SI B17 02 09  
Cooling Systems

This Service Information bulletin supersedes SI B17 02 09 **dated November 2009**.

### Oil Leak from Turbocharger Charge Air Hose

E70, E90 with M57Y diesel engine

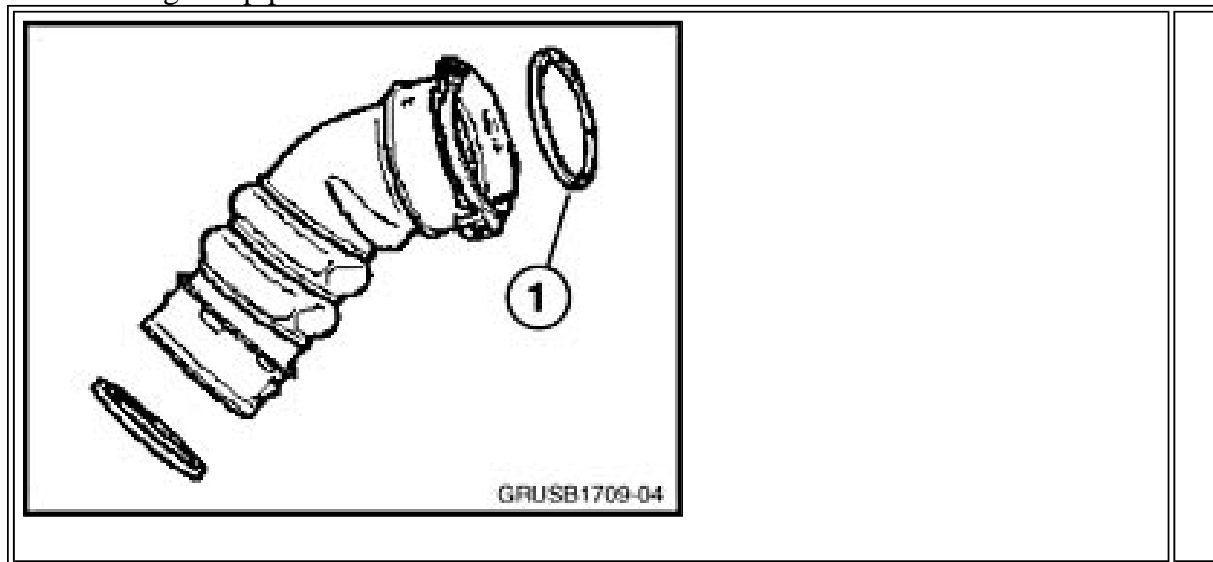
The customer may complain of an oil leak from the engine area. The "Service Engine Soon" lamp may also be illuminated with fault code "4674 - FMO injection quantities-observer" stored.

The molded seal in the charge air pipe may have been cut by debris abrasions, causing an external leak of air and oil in the charged air system of the turbocharger. An improved seal has been developed to correct this issue.

Remove the charge air pipe that connects the turbocharger to the intercooler. Thoroughly clean all mating surfaces and the charge air pipe.
